Carlsbad SUNDRY NOTICES AND REPORTS ON WELLS

Do not use thi abandoned we	s form for proposals to II. Use form 3160-3 (AP	drill or to re-enter an D) for such proposals.	OCD Dieldia Oli	ttee or Tribe Name	
SUBMIT IN TRIPLICATE - Other instructions on reverse side.				Allottee or Tribe Name	
Type of Well	ner		8. Well Name and No. GL ERWIN B NCT2 10		
 Name of Operator CHEVRON USA INCORPORA 	Contact: ATED E-Mail: djvo@chev	9. API Well No. 30-025-338			
3a. Address 15 SMITH ROAD MIDLAND, TX 79705		3b. Phone No. (include area coo Ph: 432-687-7631	de) 10. Field and Po JUSTIS	Field and Pool, or Exploratory JUSTIS

Erwin B NCT 2 -10 Temporary Abandonment Justification

GL ERWIN B NCT2 10 30-025-33803-00-C1

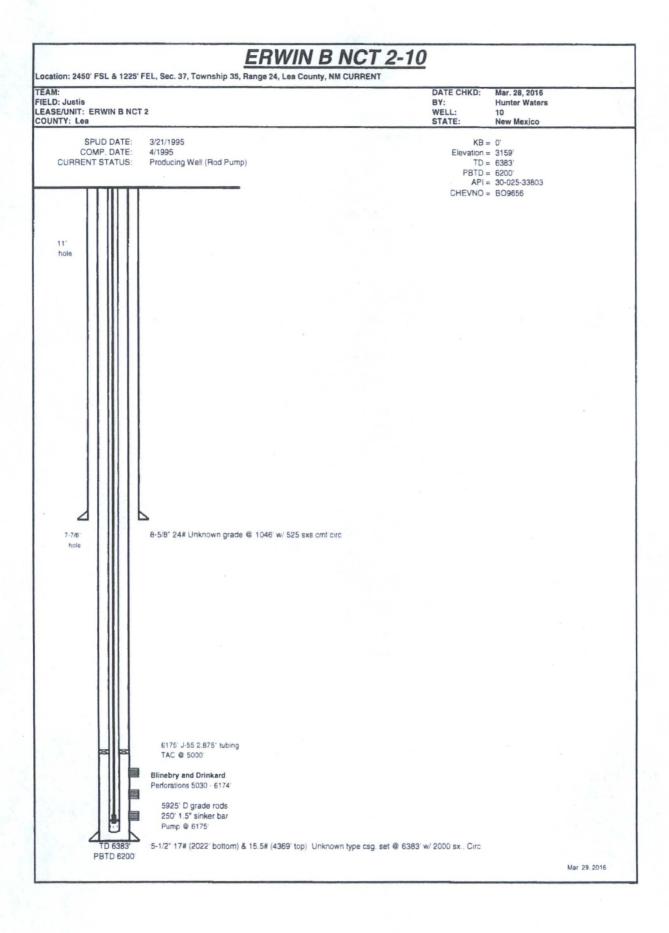
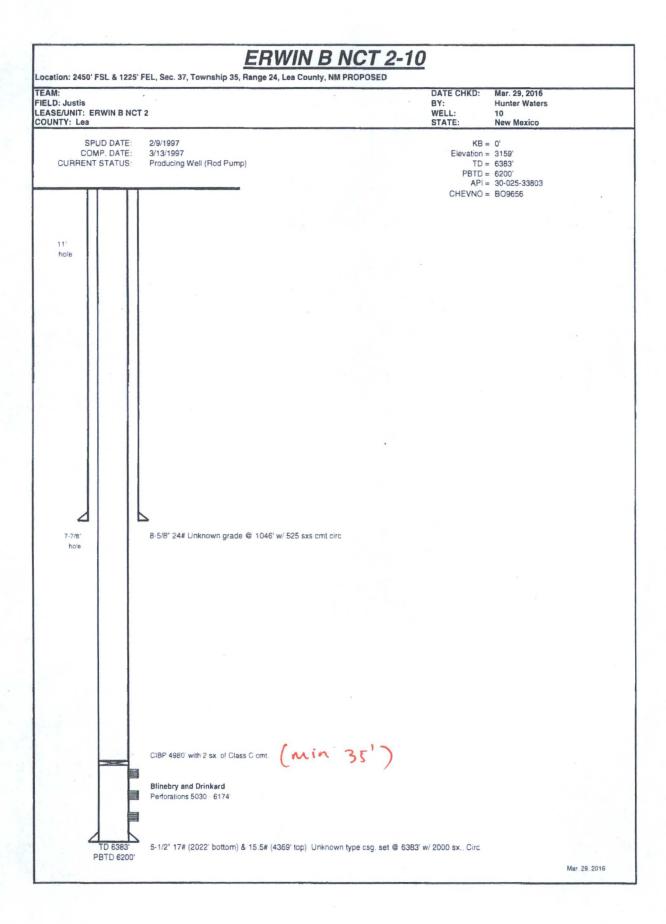
Current and proposed wellbor	e diagrams attached alor	ng with the justification.	SEE ATTACH	RECEIVED ED FOR	
			CONDITIONS	OF APPROVAL	
14. I hereby certify that the foregoing is	Electronic Submission # For CHEVRON	334887 verified by the BLM W USA INCORPORATED, sent	Vell Information System to the Hobbs on 03/30/2016 (16PP0506SE)		
	K FUENTES		JLATORY SPECIALIST		
Signature (Electronic S	Submission)	Date 03/29	/2016		
	THIS SPACE FO	OR FEDERAL OR STAT	E OFFICE REFIVED		
Approved By PETROLEUM ENGINEER		Title	7.11.11.01.20	Date	
onditions of approval, if any, are attache ertify that the applicant holds legal or equivalent would entitle the applicant to conductive the conductive to conductive the applicant to conductive the	litable title to those rights in the	s not warrant or e subject lease Office	MAR 3 1 2016 gku Muchlis Krueng

- 1. Well may be approved to be TA/SI for a period of 12 months or until 03/31/2017 after successful MIT and subsequent report is submitted.
- 2. This will be the last TA approval for this well.
- 3. Contact BLM 24 Hrs. prior to setting of plugs so as it may be witnessed.
